Product Change Notification: E-20-015245

General Product Description:
Sliver 1C to 2 OTB cable assembly

PCN-E-20-015245
Sliver 2.0 1C to 2 OTB
cable assembly
PN: 2351524-1/2

PCN Summary for 2351524-1 and 2351524-2

Molex contact change

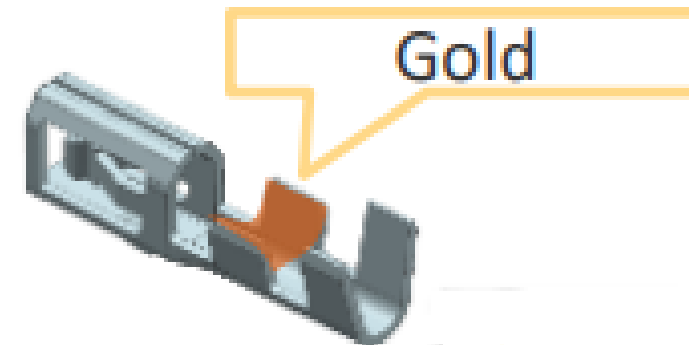
- Molex contact change from 5011935000 to 5011939000
- Tin applied on crimp barrel after crimping.

Molex PN: 501193 5000

Before change

Molex PN: 501193 9000

After change

Tin applied on crimp barrel after crimping
